UNITED STATES PATENT AND TRADEMARK OFFICE

10/038,640

| Office Action Summary | Application No. 10/038,640 | Applicant(s) STINSON, JONATHAN S. | |

DETAILED ACTION

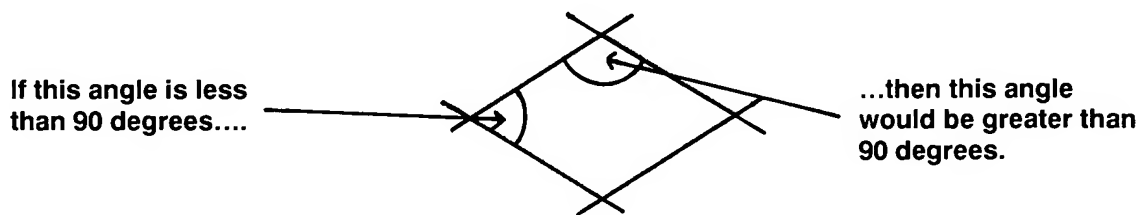
(claims 6, 76, 78, 81, 84, 86, 87 and 93) Pinchuk discloses a stent **400** comprising a body insertable structure including a plurality flexible strands **408** selectively formed to provide a discrete first tubular segment **403** and a plurality of discrete second tubular segments, or locking rings **614,616**. Pinchuk discloses that multiple locking rings can be disposed along the body of the stent, which would

Pinchuk further discloses the first and second tubular segments having respective first and second nominal diameters when the tubular structure is in a relaxed state (Fig. 6) and wherein the tubular is radially compressible against an elastic restoring force to a predetermined diameter due to the stent being a self expandable stent.

The first tubular segment **403** also has an obtuse strand crossing angle that is less than an obtuse strand crossing angle of the second tubular segment **614/616**. As seen in the attached figure below, the first tubular segment has two crossing angles: one that is less than 90 degrees and one that would inherently be greater than 90 degrees.

Therefore, since the first tubular segment **403** still has a crossing angle that is less than the crossing angle of the second tubular segment, as seen in Fig. 6, then it is inherent that the first tubular segment has a greater axial stiffness level than the second tubular segment. However, the second tubular segment will have a greater radial force level when compared to the first tubular segment because it has a higher crossing angle.
